REV.
B

AS9555

SCREW, MACHINE - DOUBLE HEXAGON EXTENDED
WASHER HEAD, CORROSION AND HEAT RESISTANT
STEEL, UNS S66286, 130 KSI MIN, .1640-36 UNJF-3A

AS9555
SHEET 1 OF 2

FIGURE 1 - SCREW

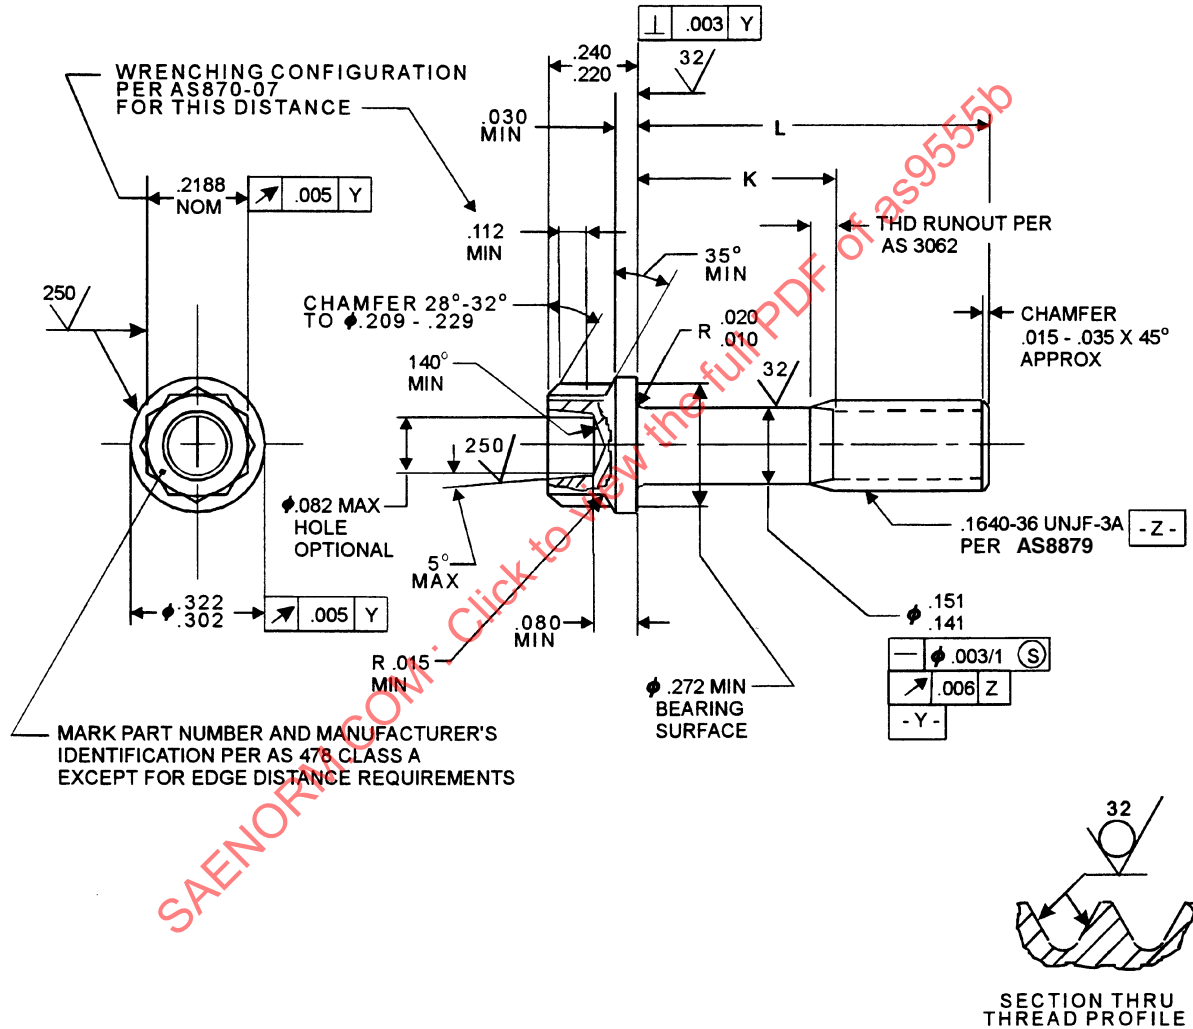
ADD DATUM REQUIREMENTS FOR -02 THRU -12 LENGTHS (NEW NOTE 1) AND REVISE THREAD SPEC TO AS8879.
